5. Homewood Subdivision; KPB File 2025-130

PLAT OF HOMEWOOD SUBDIVISION 2025 REPLAT

**ITEM #5 - PRELIMINARY PLAT
HOMEWOOD SUBDIVISION 2025 REPLAT**

KPB File No.	2025-130
Plat Committee Meeting:	September 22, 2025
Applicant / Owner:	Danielina & Mark Conway / Soldotna
Surveyor:	Jason Schollenberg / Peninsula Surveying
General Location:	Pinewood Ave and Berkenweg St off of Robinson Loop Rd

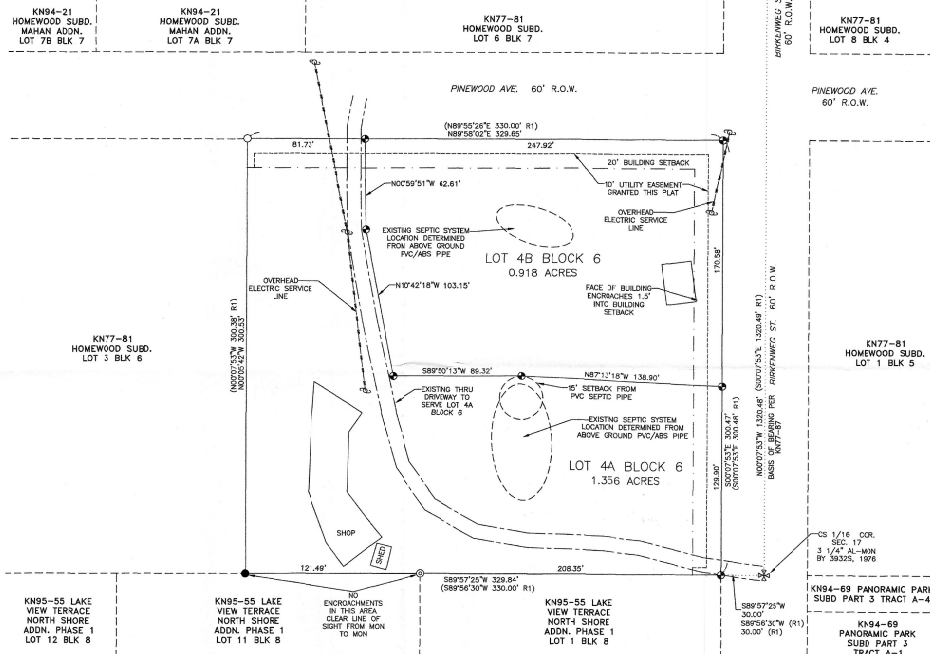
There are structures located on the property. The KPB GIS aerial photo shows a structure crossing the southern boundary. The surveyor has shown the structure on the plat drawing and noted that there is no encroachment across the southern line as there is visibility from pin to pin.

There is also a structure shown on the east side of the property. This structure is indicated to be sitting into the 20' building setback line by 1.5'. **Staff recommends** the surveyor apply for a Building Setback Encroachment Permit to address the issue of the structure across the setback line. This approval will need to be completed for final approval of the plat.

The parent plat shows a 5' easement for clearing only for overhead distribution on the east line. Staff recommends the surveyor carry this easement forward or add a plat note indicating the easement is within the 10' utility easement

The plat is adding a 10' utility easement adjoining dedicated right-of-ways and increasing to 20' within 5' of side lot lines. The drawing needs to be corrected to show the 20' increase at side lot lines near Lot 4B side lines.

There is an overhead electric service line on Lot 4A with currently no easement shown. No comment from HEA has been received at this time concerning the service line, but it is expected an easement will be requested.

The easement in book 31 page 170 does not affect this plat, plat note 4 can be removed.
In the Plat Approval, change the date to September 22, 2025

Modify the KPB File NO to 2025-130

Total area vs area of lots is off by 0.002 acres.

Check the scale of your drawing. when I put a scale on it, 330' measures out to 325' and other lines similar.ratios

Make Pinewood Ave and Berkenweg St more prominent and stand out among the other lettering.

Overhead line will need an easement covering it

Structure on east property line encroaches into building setback, need to request Building setback encroachment permit.

- Acceptance of this plat by the Borough does not indicate acceptance of any encroachments.
